# 312 Lisgar Street

Urban Design Brief  
June, 2025

# Response to Urban Design Comments

This section provides a response to comments received from Urban Design staff on January 14, 2025, following the pre-consultation meeting held on January 7, 2025.

North facade

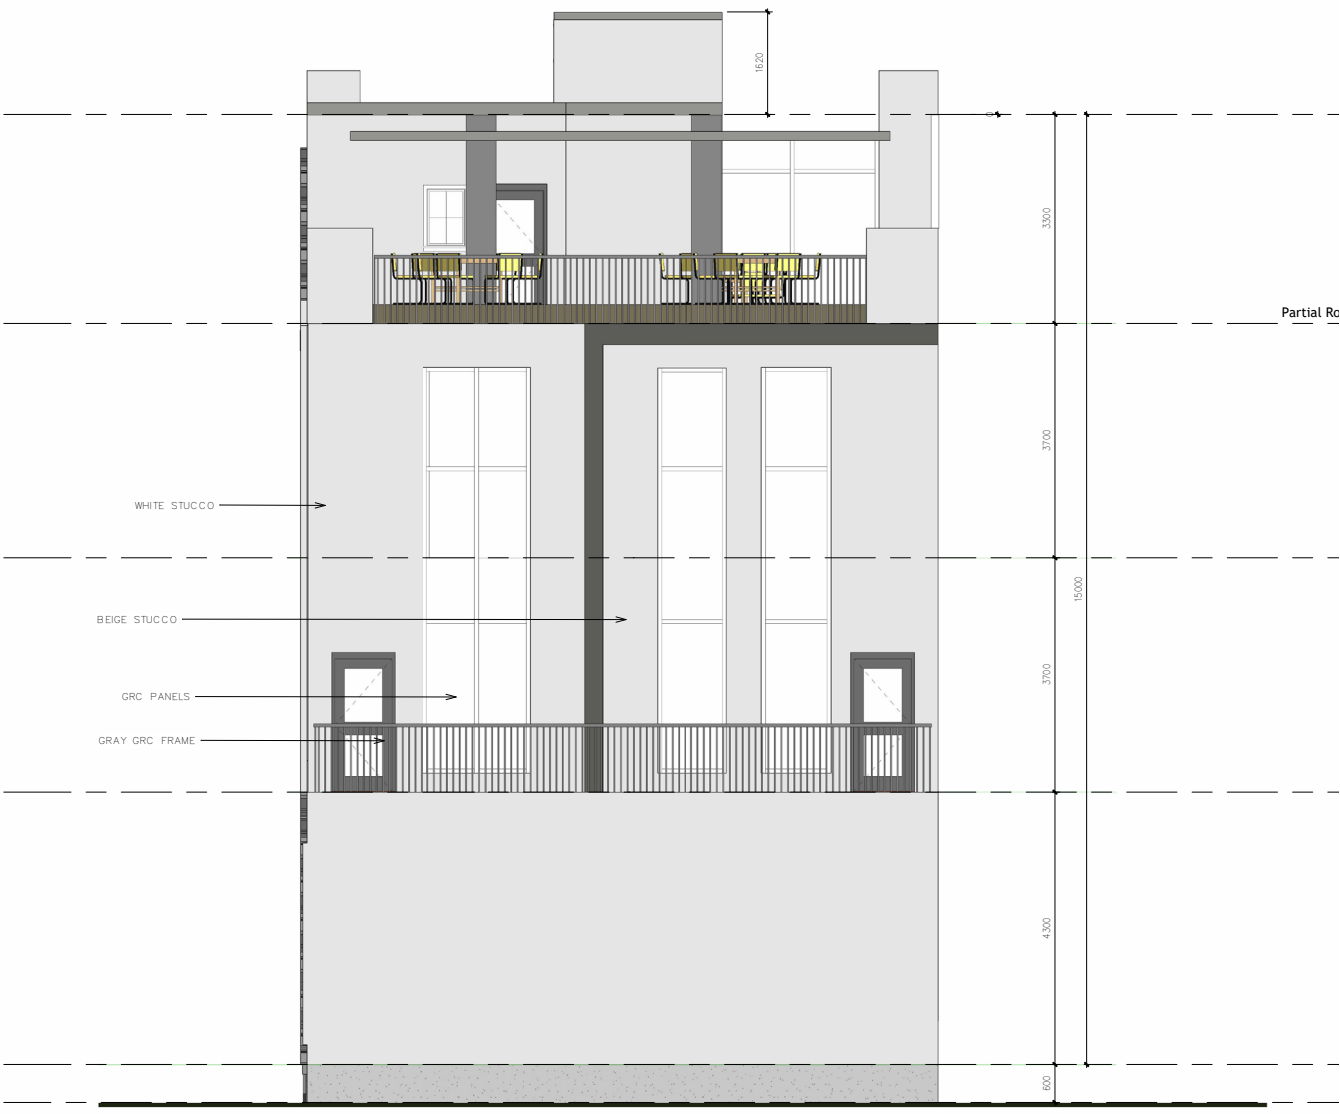
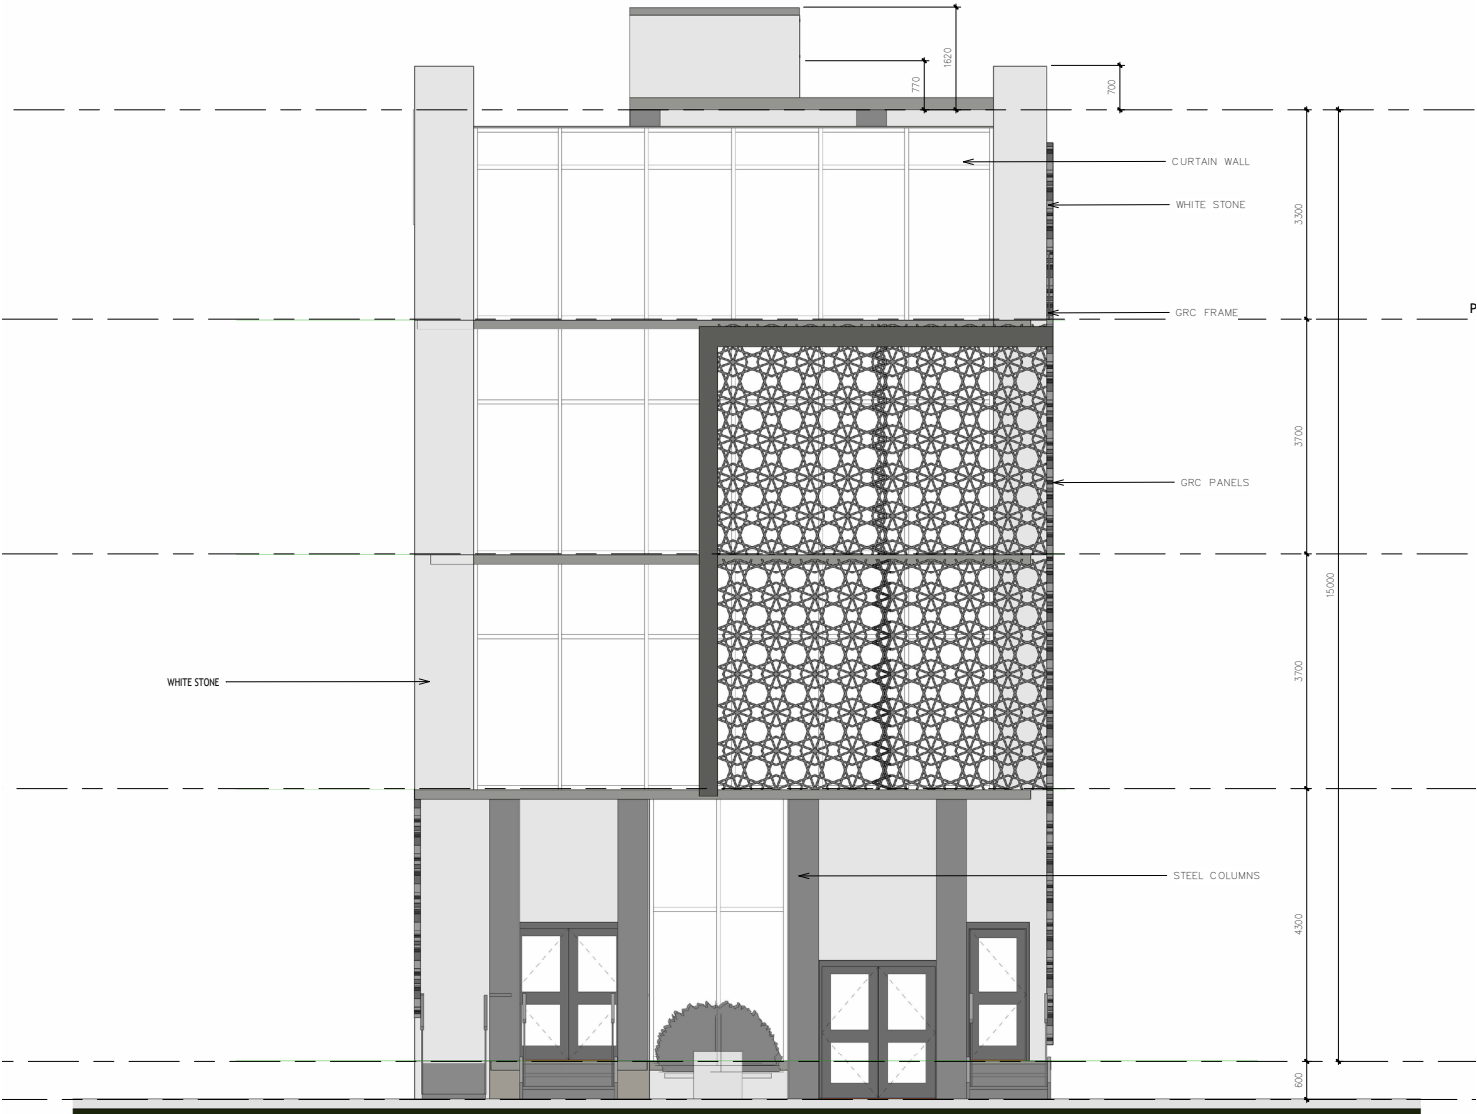
City Comment 13. With the minimal side yard setbacks proposed, please ensure that the blank wall conditions contain murals or some form of architectural treatment.

**Response: Decorative panels are proposed on the east and west facade to add visual interest along the blank walls. The ground floor is animated with transparent glazing and the upper floors are articulated with windows.**

1 North Main Elevation  
1 : 50

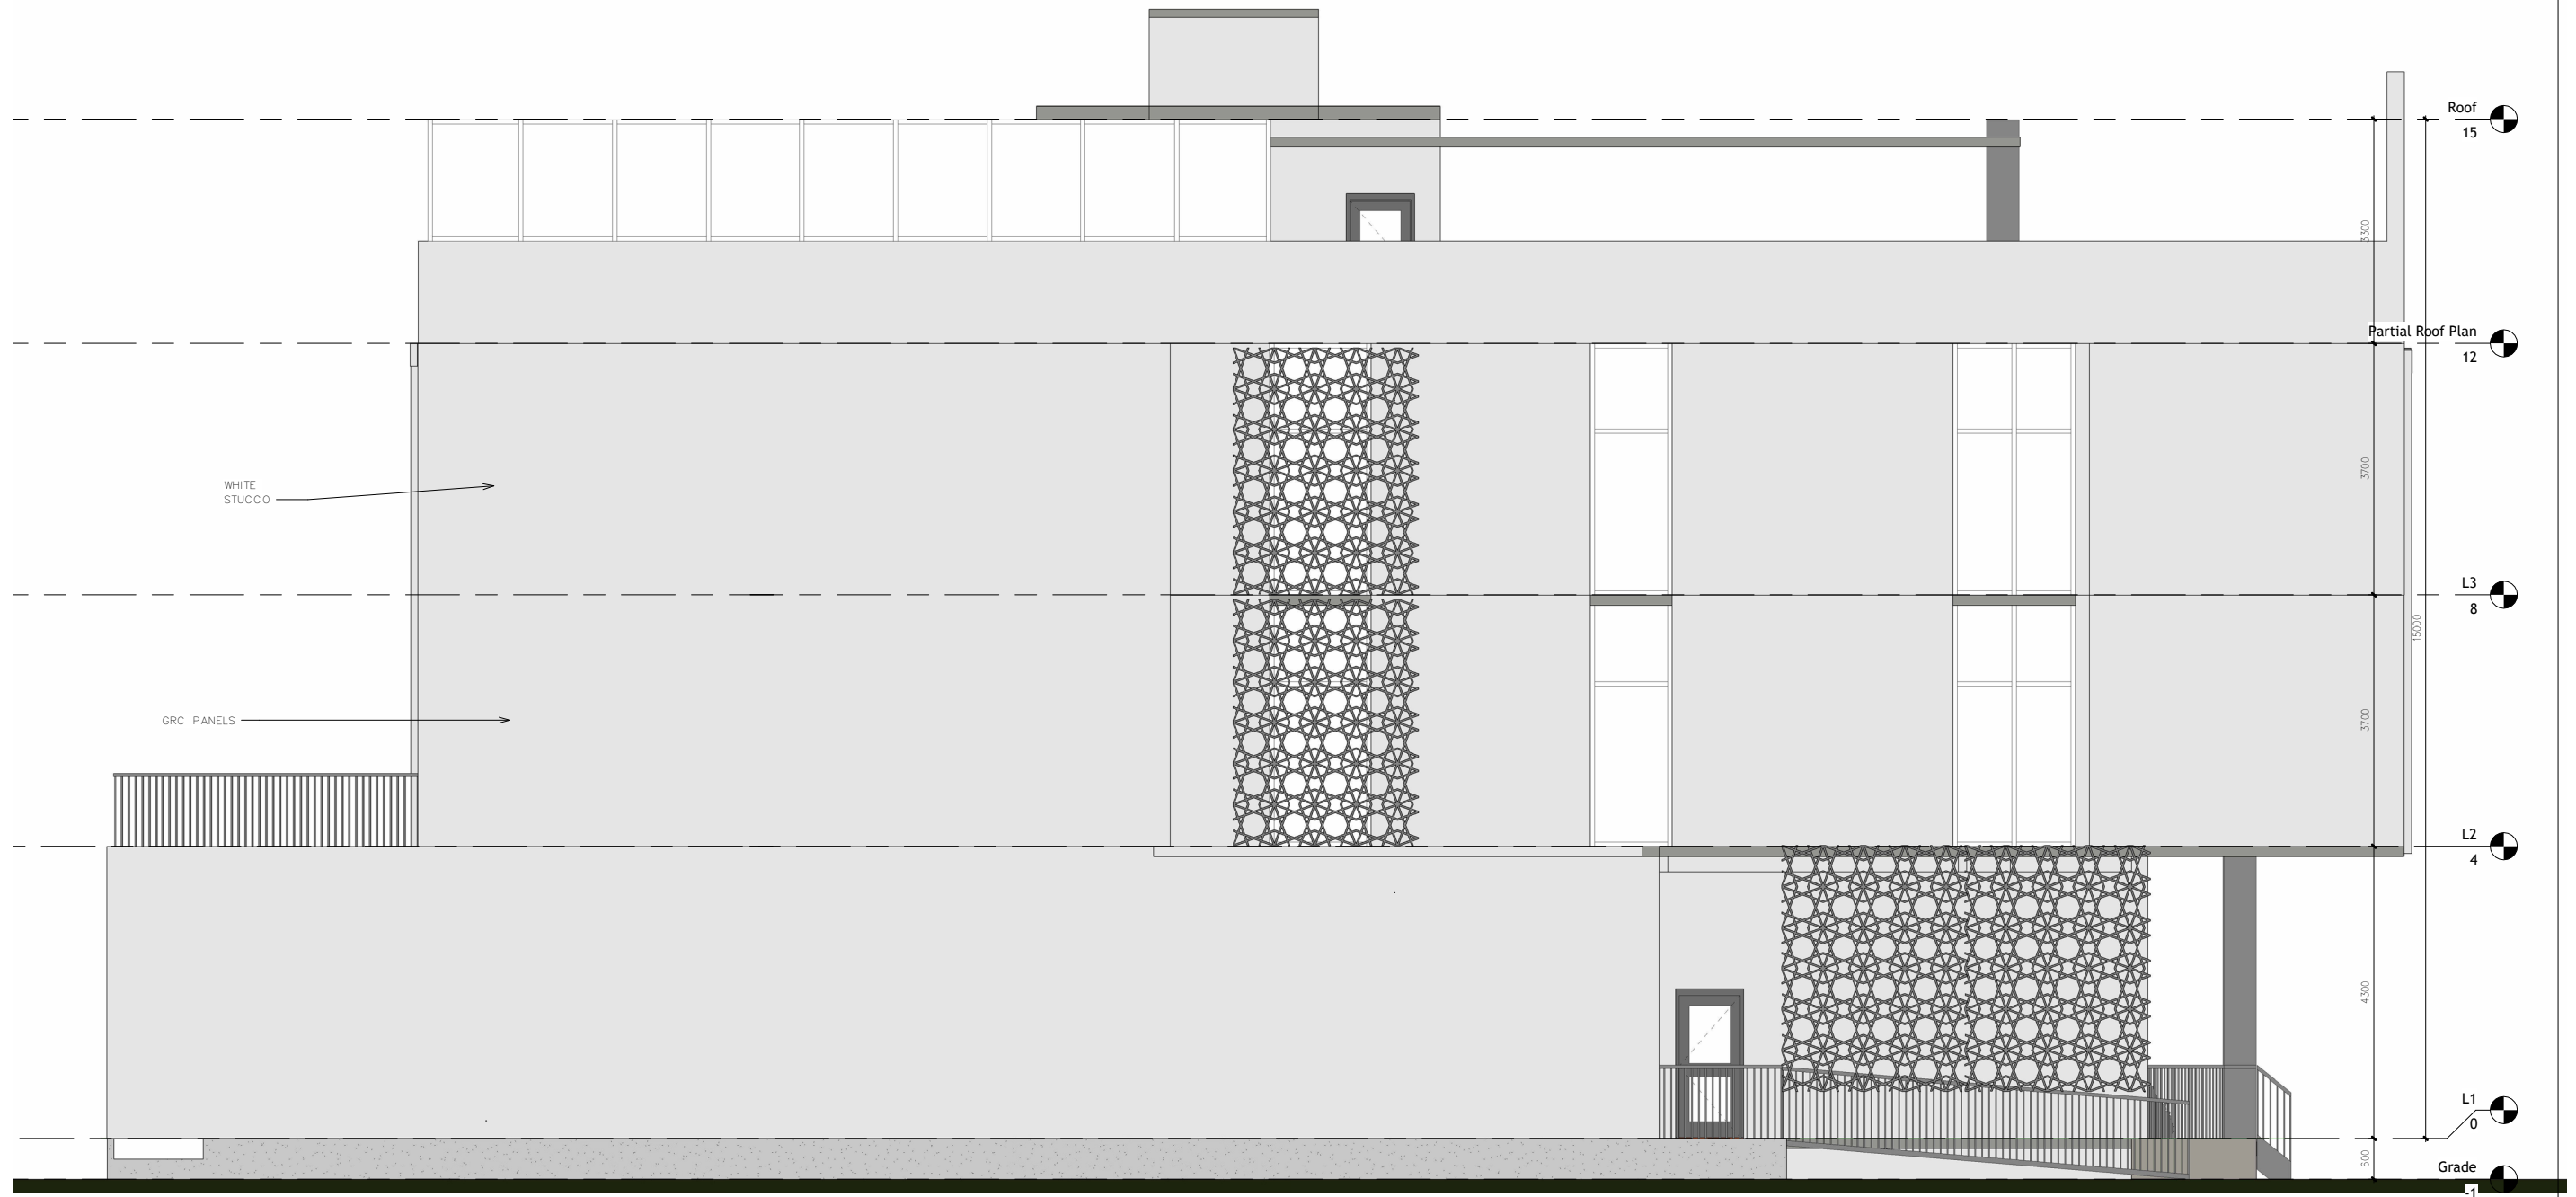
City Comment 11. Staff are generally supportive of the 5 storey built form but have questions regarding phasing and the overall aesthetic of the building if the top 2 storeys are constructed at a later date. Please provide detailed Building Elevations and a phasing strategy.

**Response: Please see the building elevations included in the submission package and on pages 8-10 of this Urban Design Brief. A three storey built form is proposed.**
